METROPOLITAN COAL MINE LONGWALLS 305-307 EXTRACTION PLAN Reasons for Approval

**Re: Advice to the Department of Planning, Industry and Environment
IEPMC 2020-01: Metropolitan Coal Mine Longwalls 305-307 Extraction Plan**

Figure 1: Zones within which higher frequency monitoring is proposed

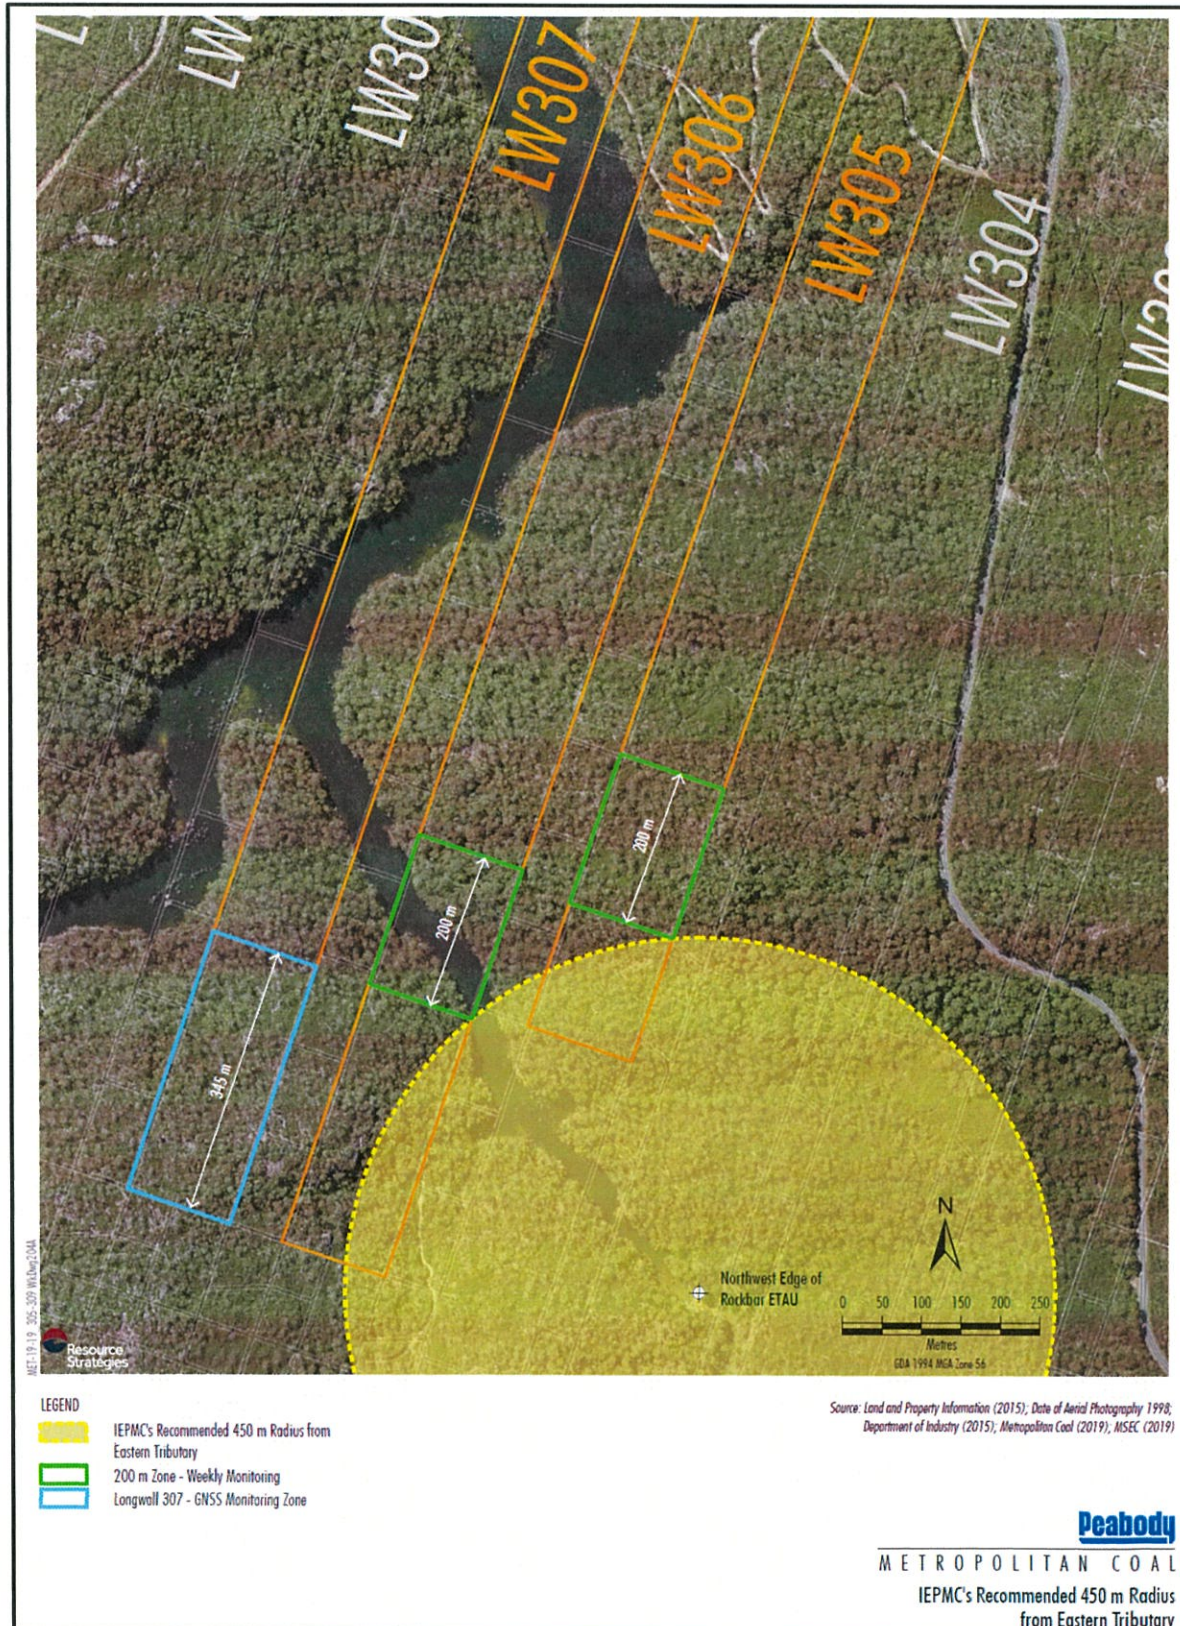
- The Department notes that the Trigger Action Response Plan for Eastern Tributary has been designed (similar to the one implemented for Longwall 304) to include higher frequency monitoring as the finishing lines of the panels are approached, as requested by WaterNSW and as recommended by the Catchment Panel and WRIS Panel. The zones in which the higher frequency monitoring would be undertaken are shown in Figure 1, which is attached to this document.

- However, as for previous longwall panels, the Department considers that higher frequency monitoring should be required as Longwalls 305 and 306 are within 200 m of the Catchment Panel's previously recommended 450 m radius from the Eastern Tributary, and within 345 m of the finish line of Longwall 307 (as shown in Figure 1 attached to this document).
